**THE U.S. ENVIRONMENTAL PROTECTION AGENCY COMMENT RESPONSES AND  
REVISIONS FOR MISCELLANEOUS SMALL STRUCTURES PROJECT IMPLEMENTATION  
PLAN AND TASK ORDER #387 ISSUANCE NOTIFICATION**

MISCELLANEOUS SMALL STRUCTURES D&D PROJECT  
IMPLEMENTATION PLAN

COMMENT RESPONSE PACKAGE

AUGUST 1998

The specific location of the Electrical Utility Tower is shown in Figure 2-1, on the following page.

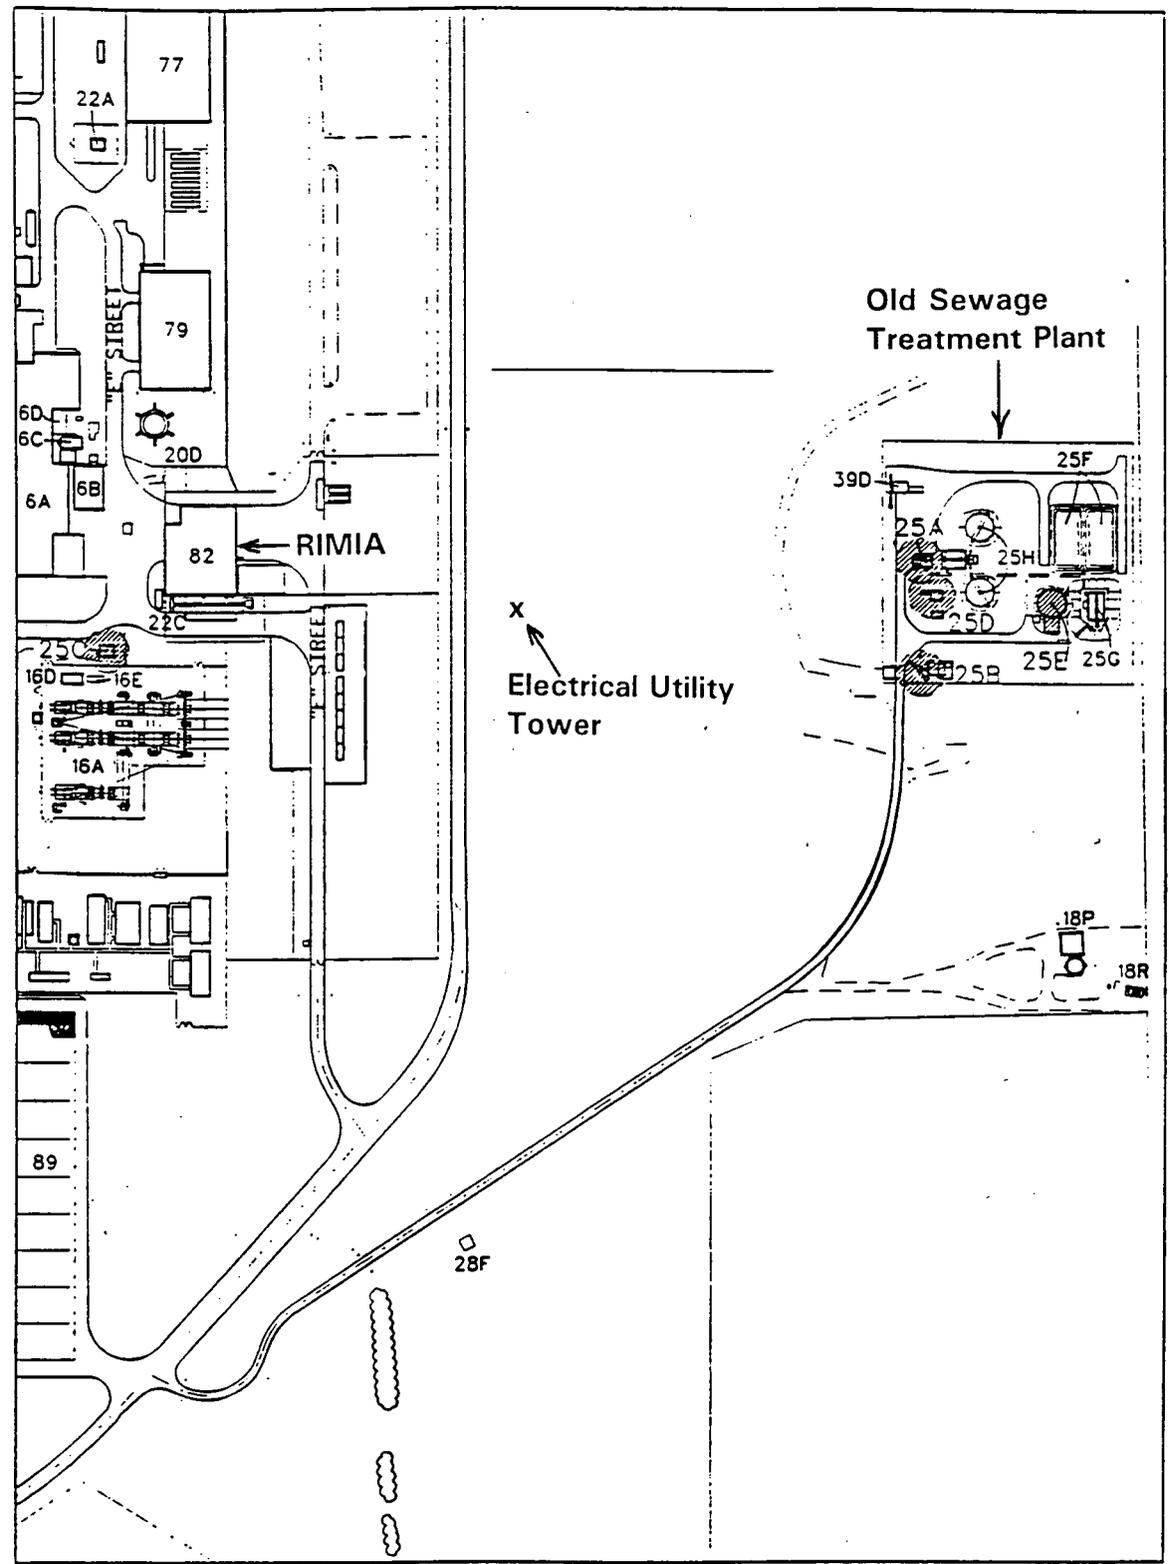
Transfer the decontamination and dismantling of an Electrical Utility Tower from the Sewage Treatment Plant Complex D&D Project to the MSS-D&D Project.

The structure is approximately 107 feet high, and is the northernmost tower (of two) located between RIMIA (82A) and the Old Sewage Treatment Plant. For the location, see Section 3 of this document, page 5 (the Electrical Utility Tower is shown in the lower right portion of the drawing).

Section 3.24 has been added to the MSS-IP, which incorporates the original write-up of the Electrical Utility Tower from the February 1998 draft of the STP Complex D&D Implementation Plan. As a result, the following redline changes to the MSS-IP are shown in Section 3 of this document:

- Page ii, new Section 3.24;
- Page 2, lines 33 - 37;
- Page 7, line 40;
- Page 14, lines 1 - 5;
- Pages 15, 16, and 17, as the last "Component Designation" in each table (the "Total" rows have been changed to include the Electrical Utility Tower figures);
- Page 24, line 32;
- Page 63, lines 1 - 18;
- Figure D-24 (structural drawing); and
- Figure E-25 (photograph).

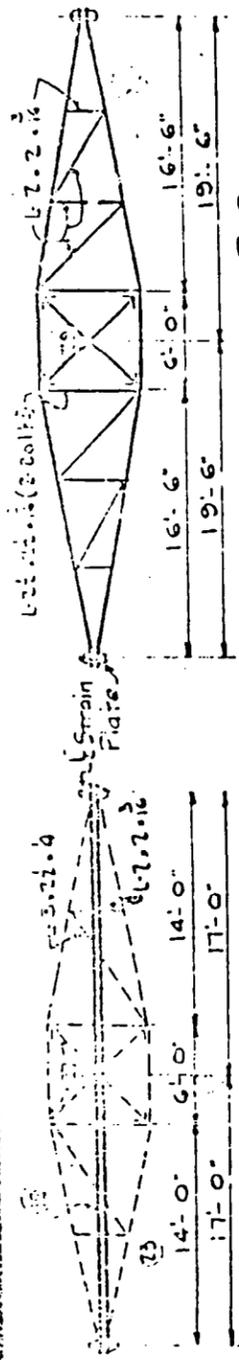
*The text in the cover letter refers to a verbal agreement between DOE and the regulatory agencies, and describes a process for communicating and documenting project information. The text in Section 4.0 of the plan contains a brief discussion of project reporting. The plan should be revised to clearly and concisely summarize project and component (or task order) communication and reporting between DOE and the regulatory agencies. Moreover, DOE's reporting procedure should include submittal of component completion letter reports. Such reports will serve to document the completion of each component's remediation and to provide updates on the overall project status.*

The agreed upon strategy is to submit an implementation schedule for each Task Order, when such Task Orders are identified (a common cost-saving practice is to include more than one component to be D&D under one Task Order; however, there is very little likelihood that any component will D&D under more than one Task Order).

DOE will notify the regulatory agencies when a Task Order has been assigned to the Site support Contractor in the form of a telephone call prior to or concurrent with the "Notice to Proceed", and this notification will be followed-up in written form through the submittal of a letter. The verbal and written notification will identify at least the Task Order scope, components, and the start and completion dates.

Each implementation schedule will contain three regulatory milestones: 1) Notice To Proceed; 2) Start of Field Activities; and 3) Completion of Field Activities. The schedule for the first components to be remediated, 38A and 38B, is shown below as Figure 4-1. Within 30 days from completion of D&D activities covered in a Task Order, DOE will provide the regulatory agencies with a Task Order Completion Report that will address the following issues:
